## **Amendments to the Drawing:**

Title: METHOD AND SYSTEM FOR MODELING DIELECTRIC LOSSES IN A TRANSMISSION LINE Inventors: Karl J. Bois et al. Docket No.: 10006879-1

Docket No.: 10006879-1 Application No.: 09/782,106

Annotated Sheet Showing Changes

Fig. 6

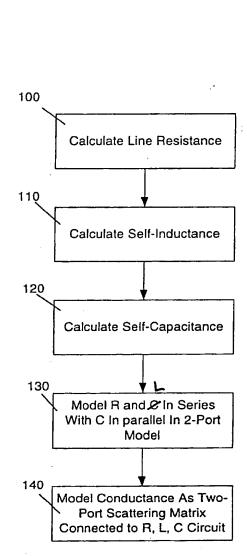
The attached sheet of drawing includes changes to Fig. 6. This sheet replaces the original sheet Fig. 6. In Figure 6, we are simply changing a C (capacitor) to an L (inductor) in block (130) diagram.

Fig. 6 has been amended as suggested by the examiner. A corrected drawing is attached to this response.
